Cub Crafters, Inc. Considers Compliance Mandatory

SUBJECT: *LANDING GEAR ATTACH BRACKET INSPECTION*

MODELS AFFECTED: CCX-2300-0001 through CCX-2300-0062; if bungee gear is installed.

Figure 1 – Clearance between Fittings

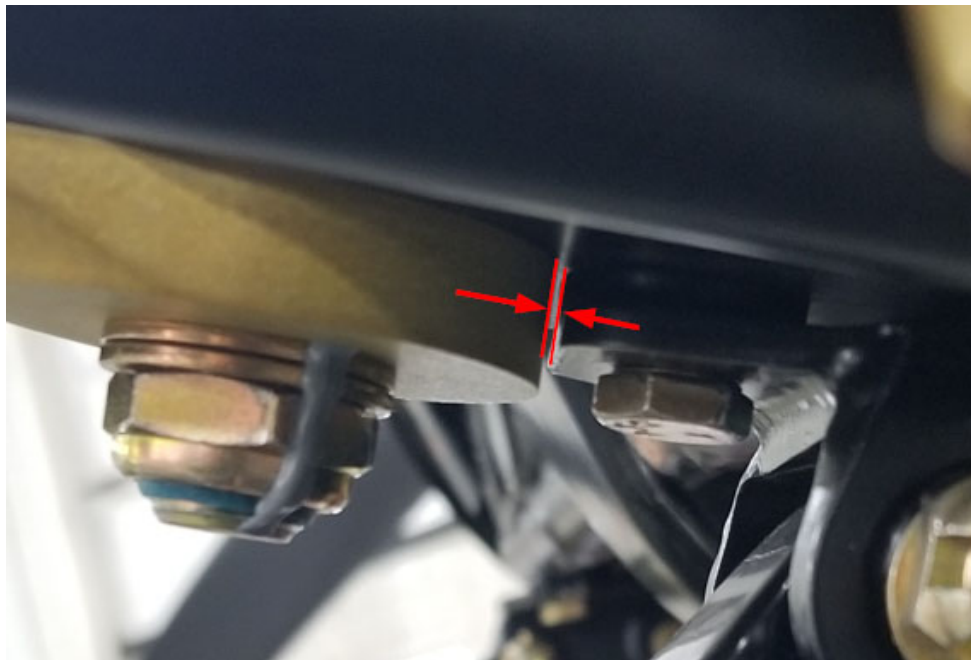
PURPOSE: *Cub Crafters has been made aware of an instance where the aft gear to fuselage attach bracket's weld bead contacted the lower fitting of the wing lift strut.*

1. Remove left and right aft fairing sets from around the gear and lift strut attachment.
2. On the bottom side of the joint, look for clearance. Any amount of clearance is sufficient. If there is clearance, skip to step 5.

3. If no clearance is found, contact customer service for a new set of landing gear brackets, XC41060-001 and XC41060-002.
4. Replace landing gear fittings per XK10000AMM section 32-10.
